REQUEST FOR INFORMATION DATE: March 06, 2017 **NO.:** RFI-470

Project Name: 15051-Webster University Interdisciplinary Science Building Project No.: 15051

Subject: Light Fixture & CUH Conflict Vestibule C250A

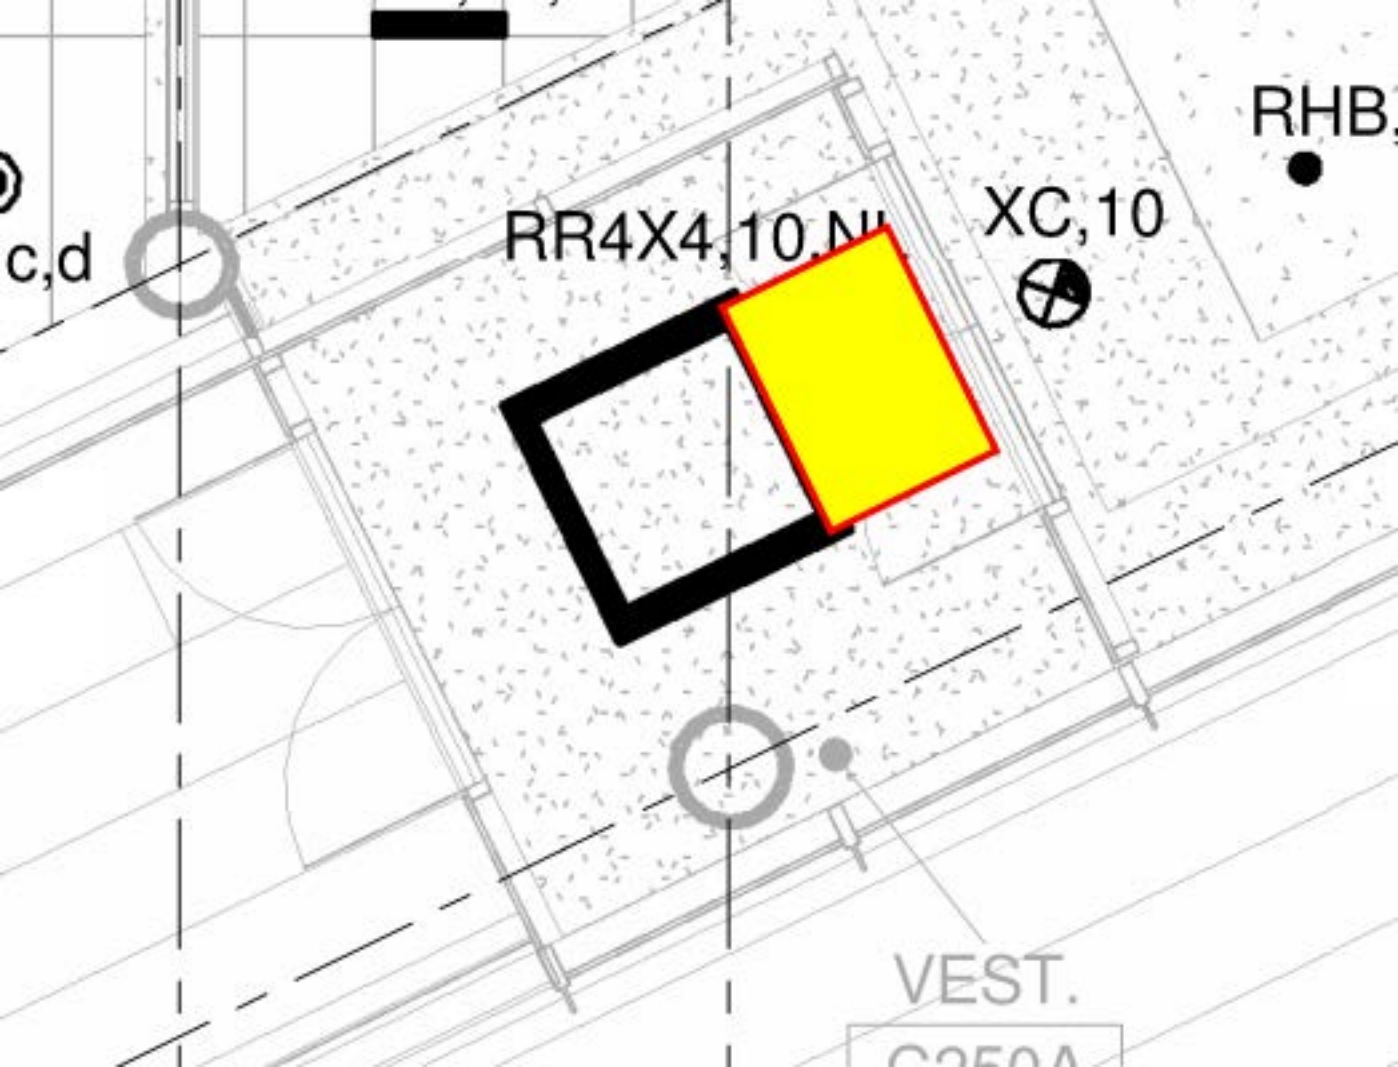
In Vestibule C250A there is a conflict between lighting and CUH-201. There is not sufficient space to install CUH-201 with the current light fixture. CUH-201 is 47.6" x 35".

Can the light fixture be shifted to the southwest or modified to accomodate CUH-201 install?

Yes, the light fixture can shift. We estimate the light fixture would not need to shift more than 5" to the southwest in order for everything to fit. Please advise if this will cause additional conflicts. The contractor shall ensure the CUH is mounted in such a way as to minimize how much the light fixture needs to shift.
